UNITED STATES
DEPARTMENT OF THE INTERIOR
BUREAU OF LAND MANAGEMENT

SUNDRY NOTICES AND REPORTS ON WELLS
Do not use this form for proposals to drill or to re-enter an abandoned well. Use Form 3160-3 (APD) for such proposals.

SANTA FE G 2

Burlington Resources requests permission to P&A the referenced well per the attached procedure, current & proposed wellbore schematics. A C-144 was submitted on 5/13/13 and approved on 5/16/13.

Proposed Schematic

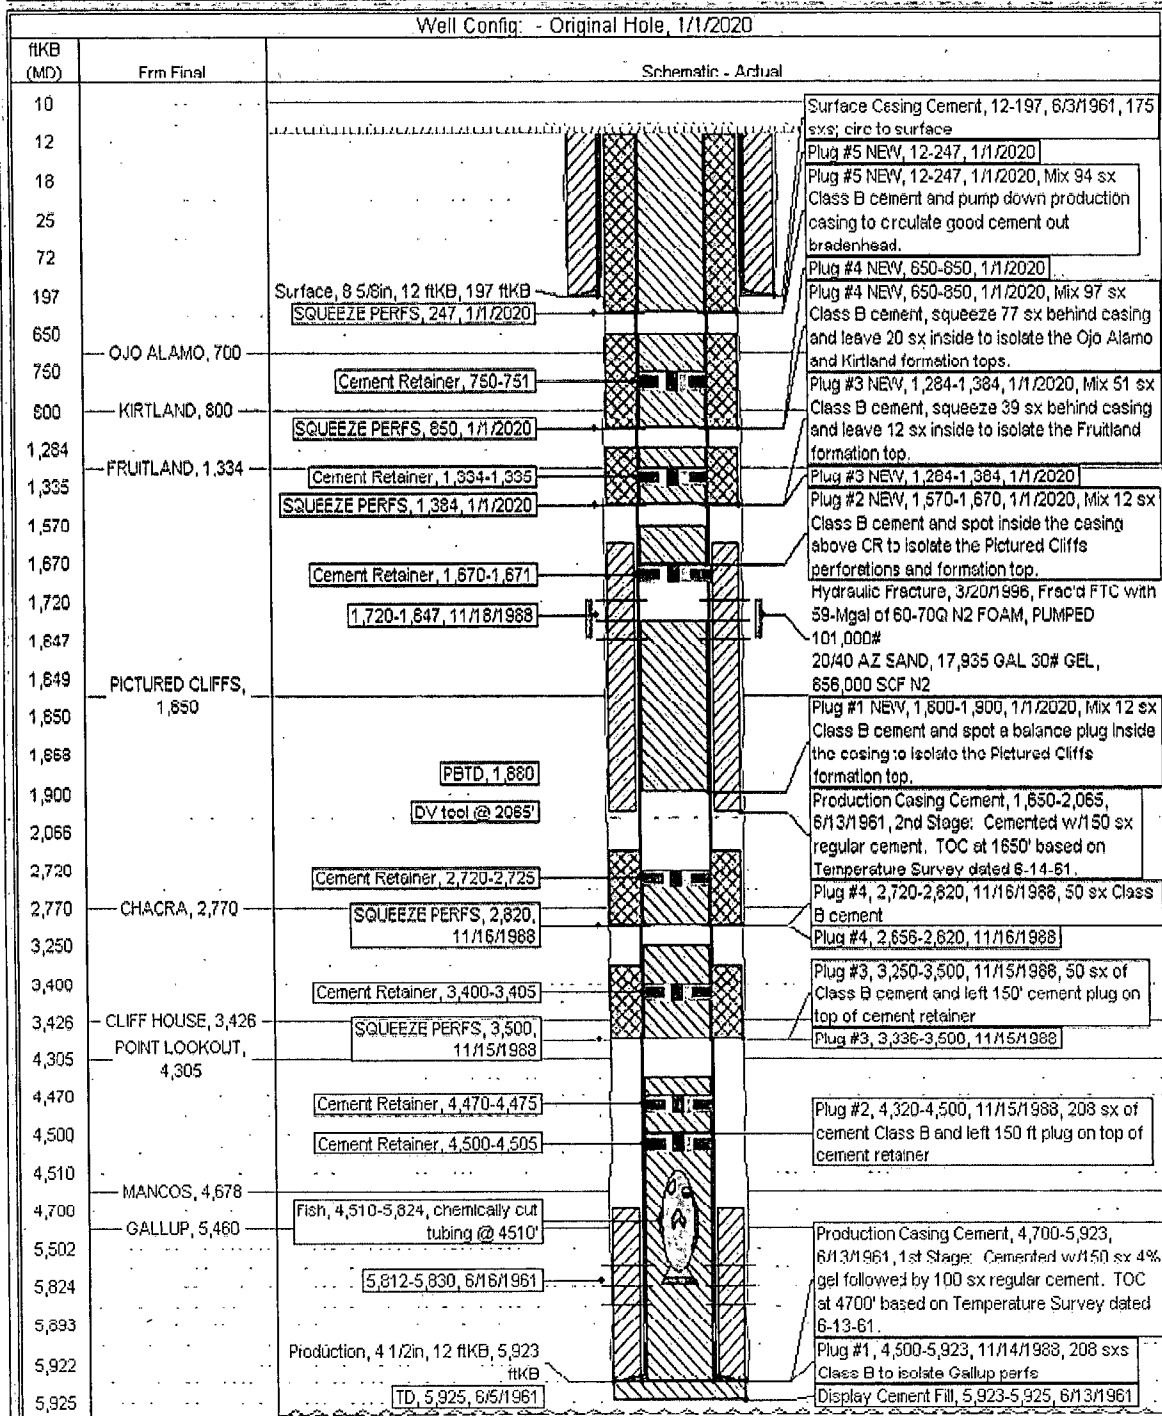
1. Plugging operations authorized are subject to the attached "General Requirements for Permanent Abandonment of Wells on Federal and Indian Lease."
2. Farmington Office is to be notified at least 24 hours before the plugging operations commence (505) 564-7750.
3. The following modifications to your plugging program are to be made:
 - a) Place the Pictured Cliffs/Fruitland plug from 1670' – 1490'.

You are also required to place cement excesses per 4.2 and 4.4 of the attached General Requirements.
